# **SOUTHEAST AURORA MAINTENANCE FACILITY PUBLIC IMPROVEMENT PLAN**

**JULY 2020**

**For:**  
**Aurora Water**  
**15151 E. Alameda Parkway**  
**Aurora, CO 80012**

**Prepared By:**  
**Calibre Engineering, Inc.**  
**9090 S. Ridgeline Blvd. Suite 105**  
**Highlands Ranch, CO 80129**

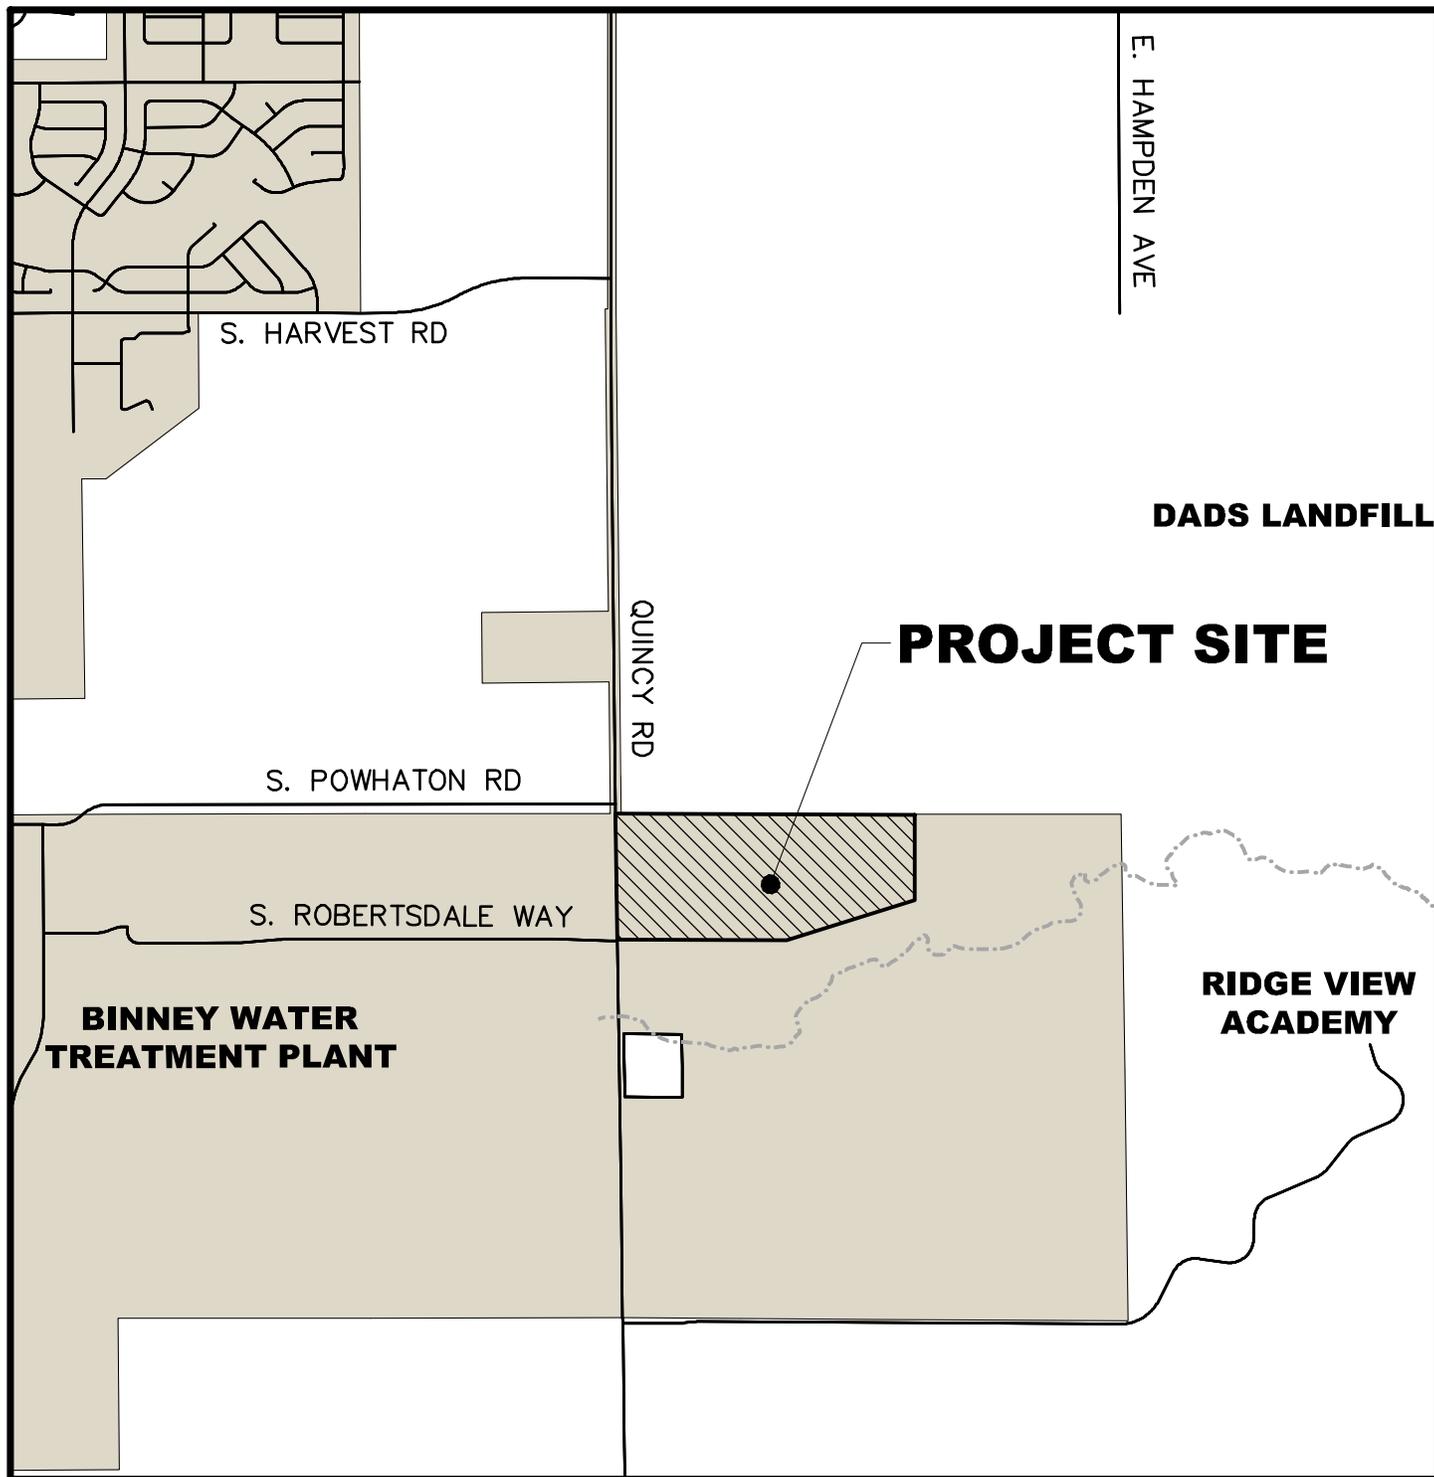
If a deferral is granted, design of the ultimate improvements are required and need to be included in the site plan and civil plans. The deferral is for only the construction of the improvements

As discussed with COA staff the ultimate typical section for Quincy Ave was added and we are requesting a deferral both design and construction.

**AURORA SEAM**  
 VICINITY MAP

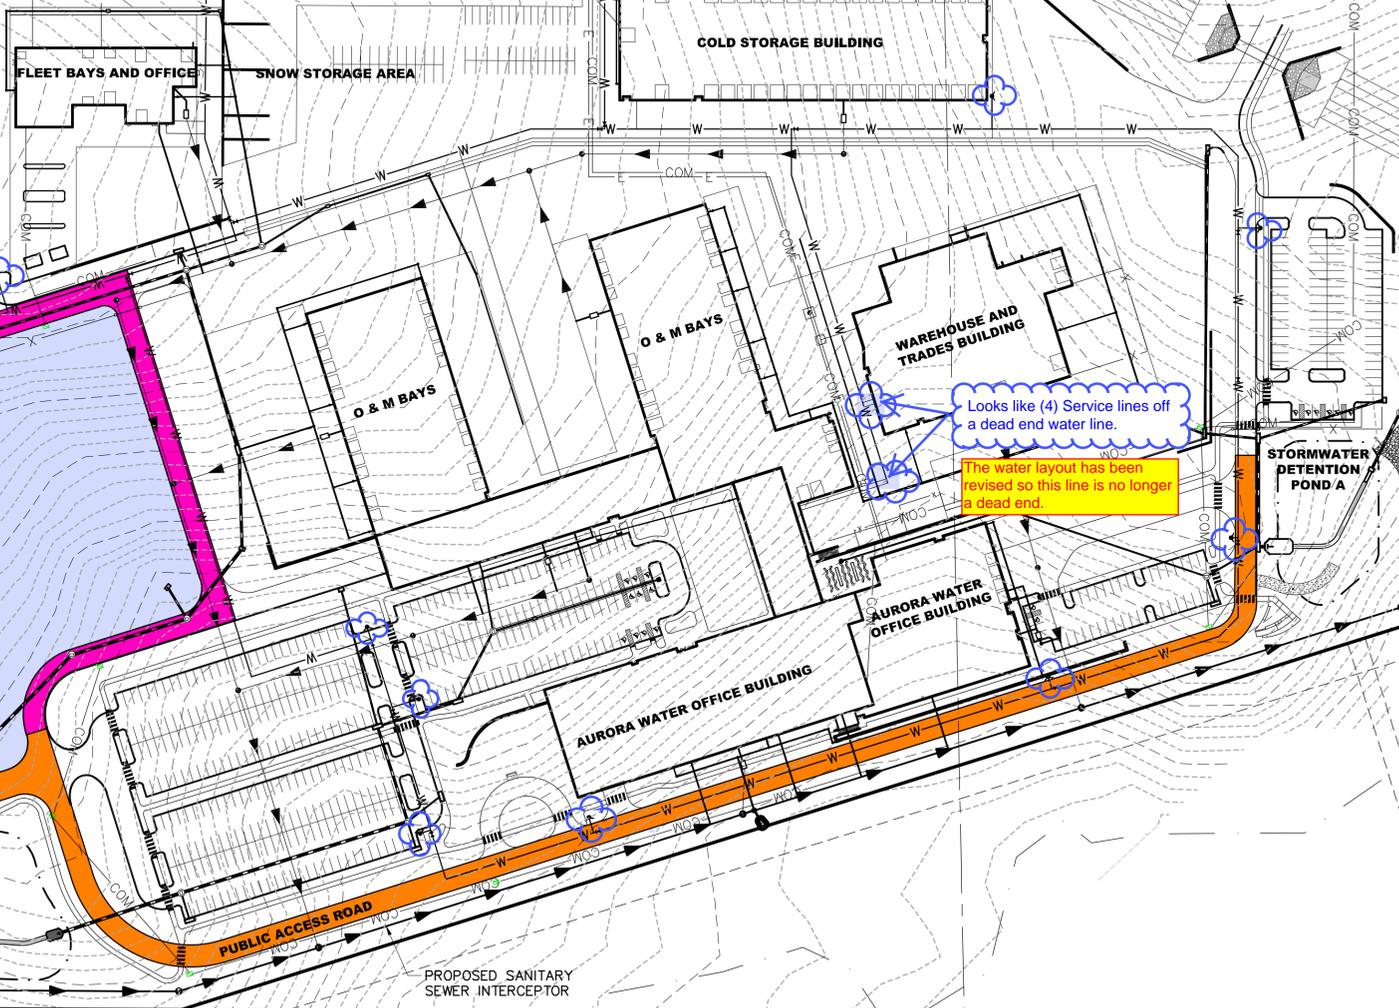
**NOTE:** Please relocate all Fire Hydrants per the Architectural Sheet AC1.1

Include the ultimate improvements for Quincy Avenue as well as the interim improvements. Show ROW

Looks like (4) Service lines of a dead end water line.

Please do not include the master drainage report in the PIP. Facilities identified in the MDR shall be shown on the PIP exhibit

The fire hydrants have been located within 100-feet of the FDC. There were several updates made to the FDCs on this submittal.

The ultimate section was added at the bottom of this sheet.

The water layout has been revised so this line is no longer a dead end.

The MDR was removed.
